Planning Commission Meeting

Date: November 1, 2021

Subject: Site Plan Review – Lot 6 & 7, Meridian First Subdivision - Multi-tenant mixed use

• Request approval of site plan for a multi-tenant commercial building

LANDSCAPE

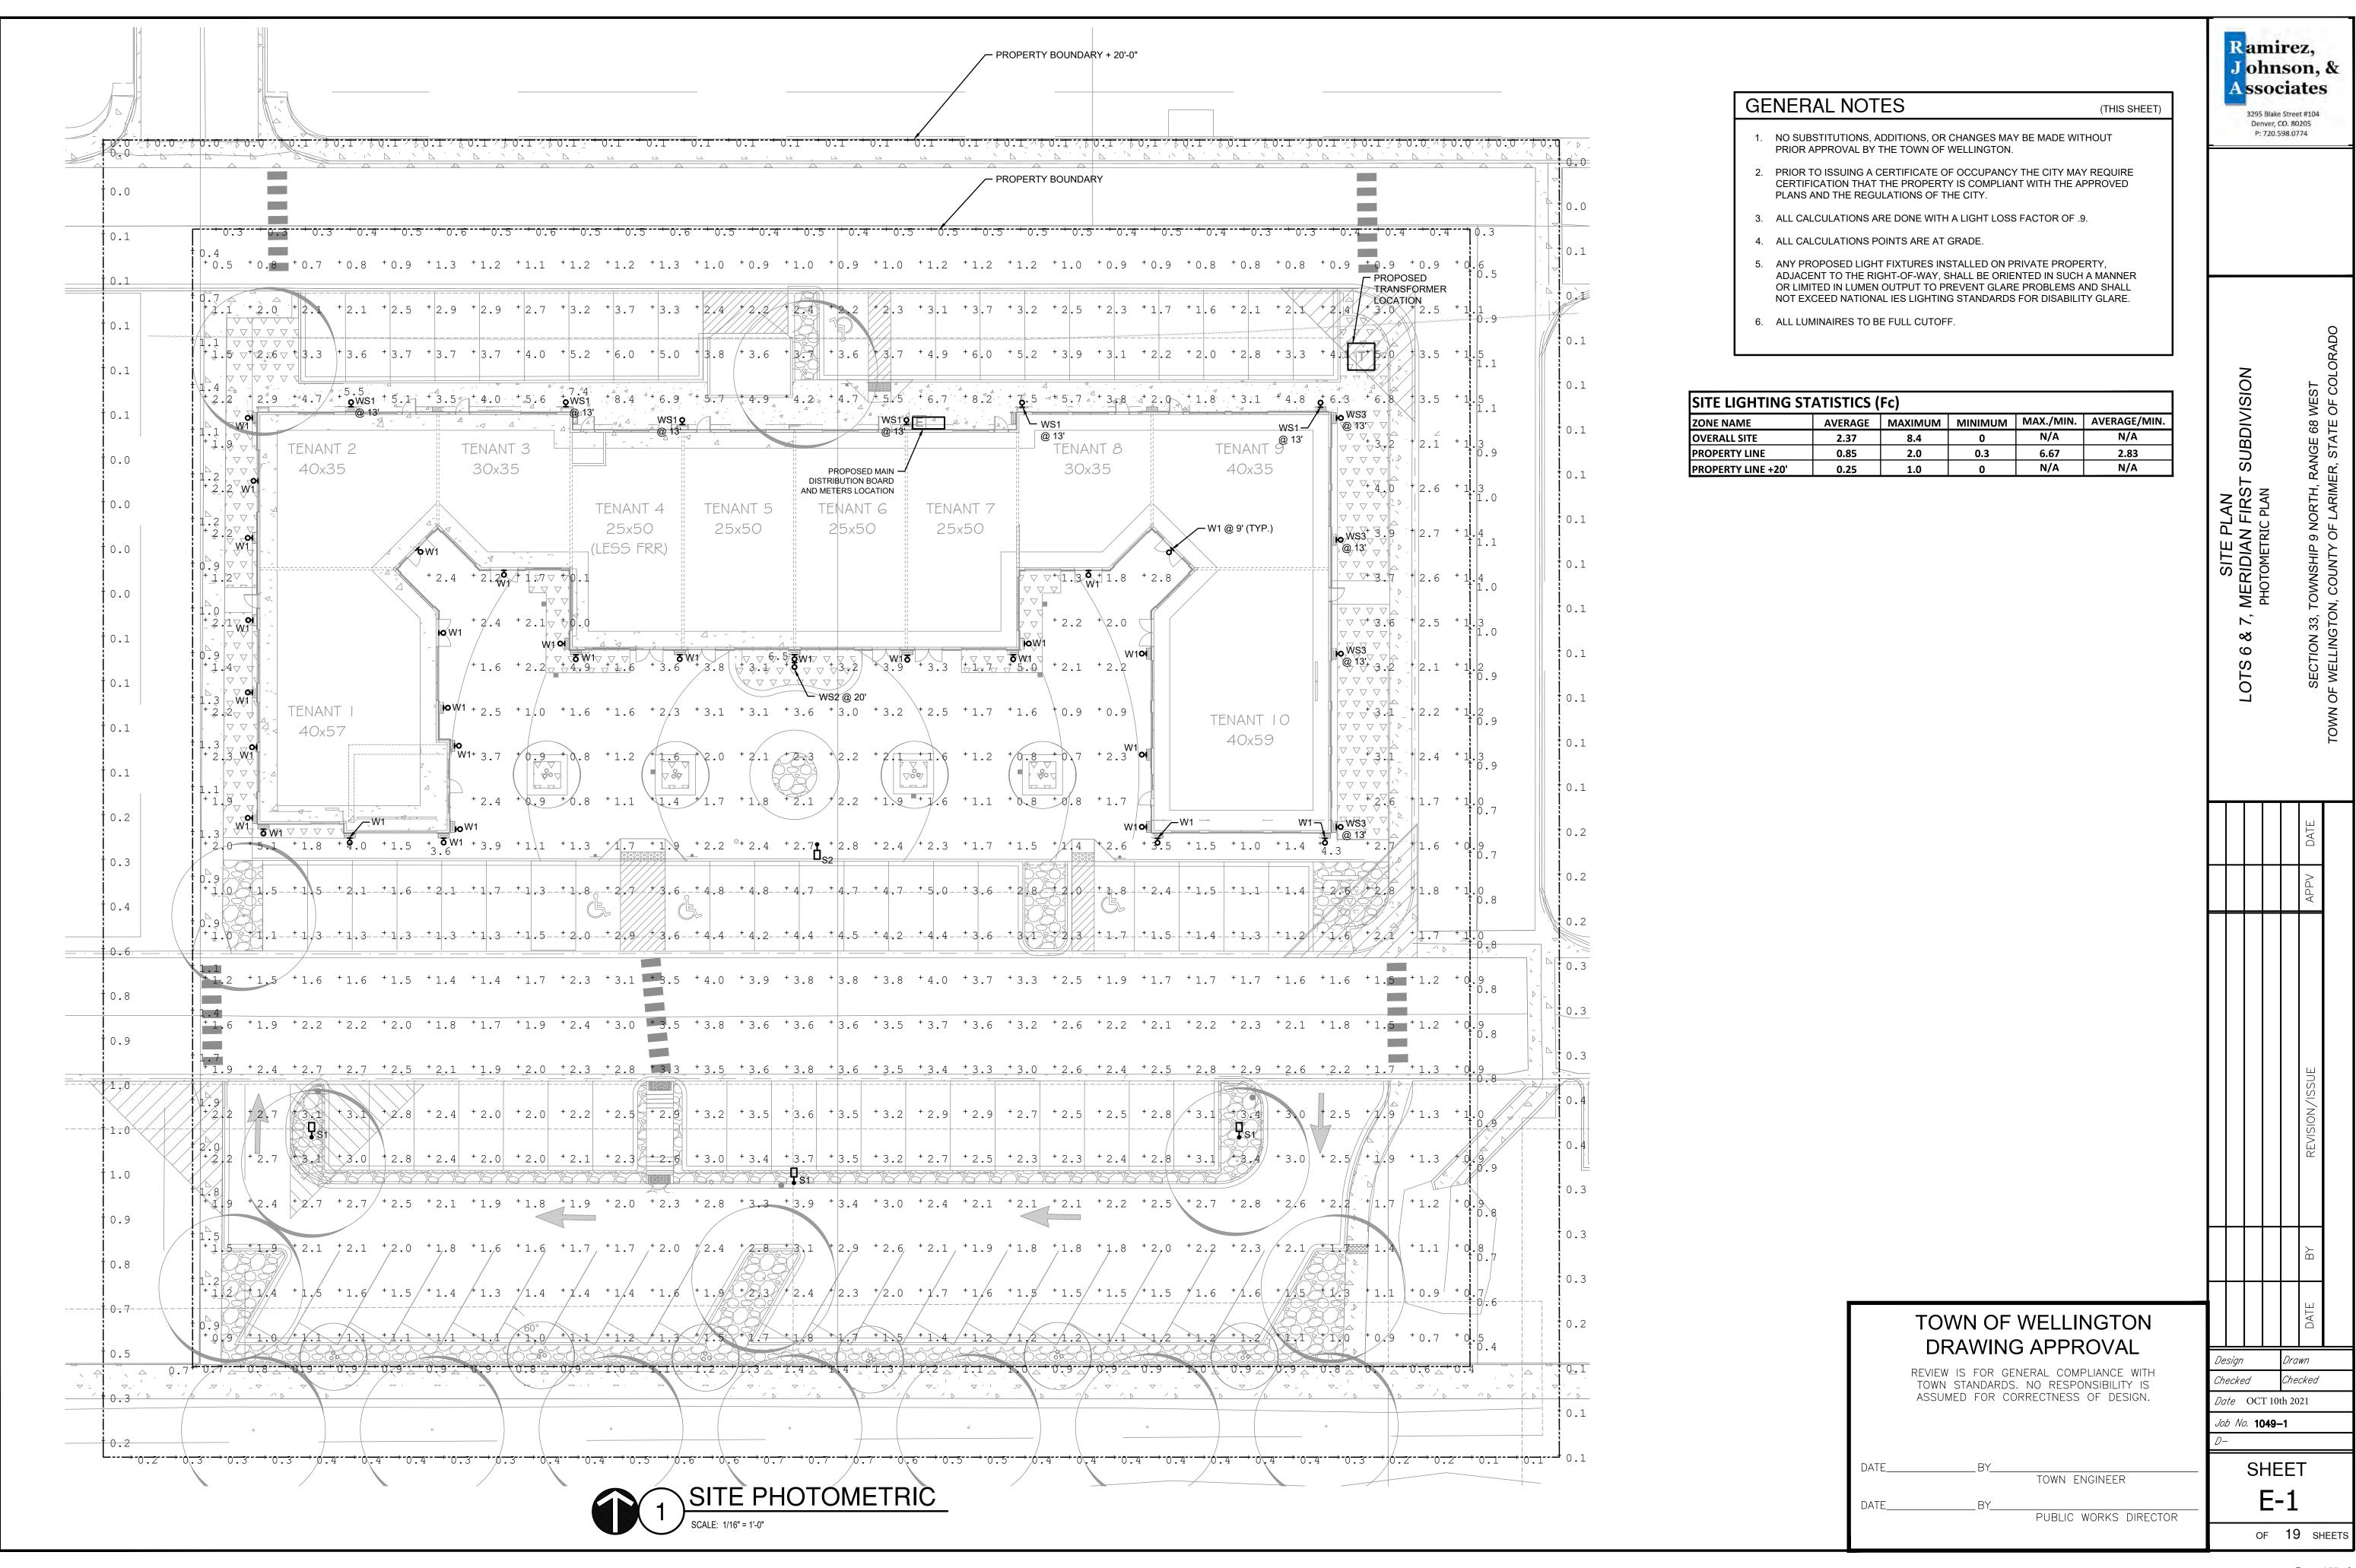
- The landscape plan identifies an 8' existing sidewalk on the south side of the parking lot (near the property boundary) which is represented in the civil drawings as a 7.5' sidewalk. The applicant should verify the width of the existing sidewalk and update plans as needed; this discrepancy still exists and has not been completed.

- Ensure coordination between the landscape plan and lighting plan. Light locations are identified on the landscape plan, but locations appear to be slightly different and can become a conflict in the field. There is no change on the plans and no text response from the applicant regarding this comment.

- Staff counted 31 trees; 30 are noted in the "minimum site landscape calculations" and 29 are shown in the "plant list phase 1." Please confirm and edit the calculations as appropriate to remove discrepancies.

- Staff counted different numbers for EAC (Dwarf Burning Bush), KA (Karl Forester), and PAH (Dwarf Fountain Grass) than what is noted on the Plant List Phase 1. Please edit the document as appropriate to reflect accurate counts of landscaping items.

- The applicant will need to ensure tree locations and light pole locations do not conflict on the revised drawings. There is no change on the plans and no text response from the applicant regarding this comment.

- 6. Meet the minimum landscaping requirements, especially for total trees.
 - Response: We updated landscaping to meet minimum landscaping requirements including total number of trees. Please refer to sheet L1.0 for the updated landscaping.

- Response: Updated the landscaping plan to note that trees within the site triangle must be properly pruned. Please refer to sheet L1.0.
- 8. Provide an irrigation plan.
